# OTS Conference Highlights

## Sportsfield Drainage: Learning from Mistakes (Case 2)

DR. BOB SHEARD, P. AG., AGRONOMIST, GUELPH TURFGRASS INSTITUTE

**Figure 1: A schematic drawing of the soil profile of the soccer field.**

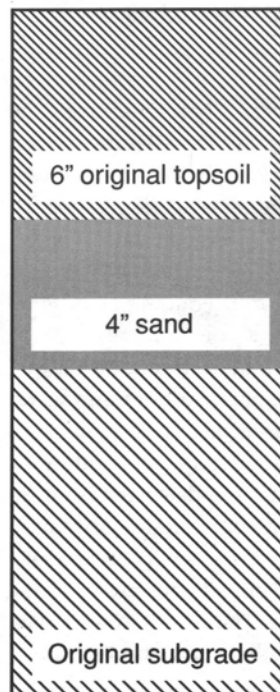
There were two major errors in design and construction. The major problem was the sand layer below the topsoil which created two zones of pore size discontinuity. The first zone was between the subgrade and the sand layer. At the interface of the subgrade and the sand there is a change from relatively large pores in the sand to very small pores in the subgrade. As often happens in sports field construction, the earth moving was done in the fall under wet conditions with large-size, earth moving machinery. This operation resulted in a compacted subgrade with further reduction in porosity through which one would expect a very low rate of water movement. Thus, winter snows and spring rains would keep the sand layer saturated for a long time in the spring. In turn, the water in the saturated sand layer would rise into the topsoil by capillary action, keeping the surface soft and resulting in the observed rutting by the tractors.

interface between the sand layer and the topsoil. Here the discontinuity is in the reverse direction where relatively fine pores in the topsoil overlay large pores in the sand. Initially in the spring, drying out would be delayed because a perched water table would develop in the topsoil at this interface, adding to the wetness of the surface. When the system finally dried out during midsummer, capillary flow of water from the subgrade upwards through the sand to the topsoil would be interrupted resulting in the turf having to rely only on the available water stored in the 15 cm of topsoil.

The second error in the design was the use of an excessive crown as a substitute for drainage. Although a 2.0% grade would effectively shed most of the water if the field were a bare parking lot, a dense turf, the prime prerequisite of a good soccer field, is the best system known to soil conservationists to prevent run-off. If run-off is prevented through the turf cover, the water which falls on the surface must infiltrate the soil surface and be removed by natural or artificial internal drainage systems. While a crown may be of value in a parking lot, it adds little to the drainage of a sports field.
